## SUNDRY NOTICES AND REPORTS ON WELLS

2. Name of Operator BOPCO, L. P.		Poker Lake Unit 443H			
BOFCO, L. F.		9. API Well-No.			
a Address	3b. Phone No. (include area code)	30-015-41198			
P. O. Box 2760 Midland, TX 79702	432-683-2277	10. Field and Pool, or Exploratory Area			
Location of Well (Footage, Sec., T., R., M., or Surv	ey Description)	Nash Draw (Del, BS, AV)

BOPCO, L.P. respectfully requests the change of plans as attached.

Poker Lake Unit 443H 30-015-41198 BOPCO, L.P. May 22, 2013 Conditions of Approval

PROJECT: Poker Lake Unit #443H

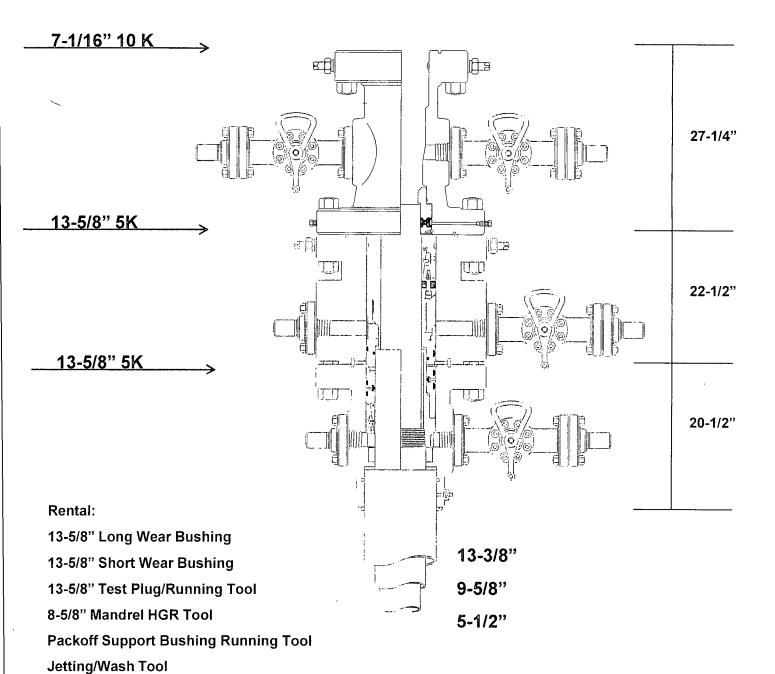
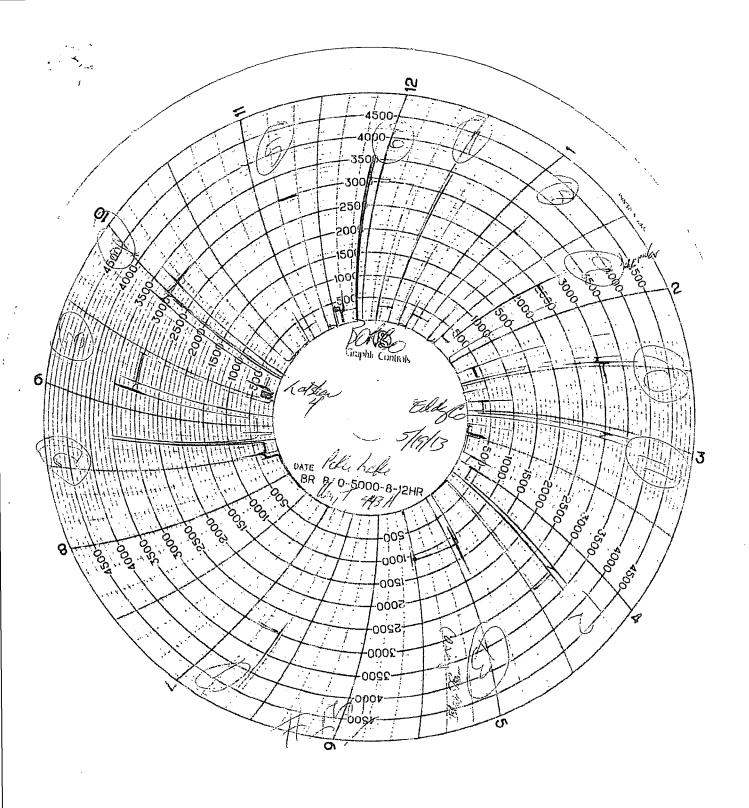
BOPCO, L.P. respectfully requests to use a 13-5/8" 5,000 psi Cameron MBS wellhead system for the PLU #443H. Please find wellhead schematic attached. The Cameron MBS wellhead was installed on the 13-3/8", 48 ppf, H-40, surface casing on 5/19/2013. The weld was tested to 500 psi under the supervision of a Cameron wellhead hand. Please find field report attached.

- 1. Operator has installed and tested a multi-bowl wellhead assembly prior to approval. This assembly was tested when installed on the 13-3/8" surface casing. Minimum working pressure of the blowout preventer (BOP) and related equipment (BOPE) required for drilling below the surface casing shoe shall be 3000 (3M) psi. BLM is granting approval to continue use of the Cameron multi-bowl wellhead assembly by BOPCO abiding by items b. d. listed below.

- a. Operator submitted documentation that a manufacturer's representative installed the wellhead.
  - b. Operator shall perform the 9-5/8" and 7" casing tests to 70% of the casing burst. This will test the multi-bowl seals. These tests shall be charted and held for 30 minutes. Submit test charts with subsequent report sundry on drilling operations.

- c. In addition to testing the flange fitting that was disconnected, operator shall also test the manual valve below I-BOP hydraulic valve that was missed in the original test. The rig has already been informed of the need for this test.

- d. The operator shall monitor the mud system for possible gas kicks until such time that the 7" production casing is cemented as the set point of the 9-5/8" casing restricts when the BOP can be closed without creating the potential for an underground blowout. An underground blowout is considered an undesirable event.
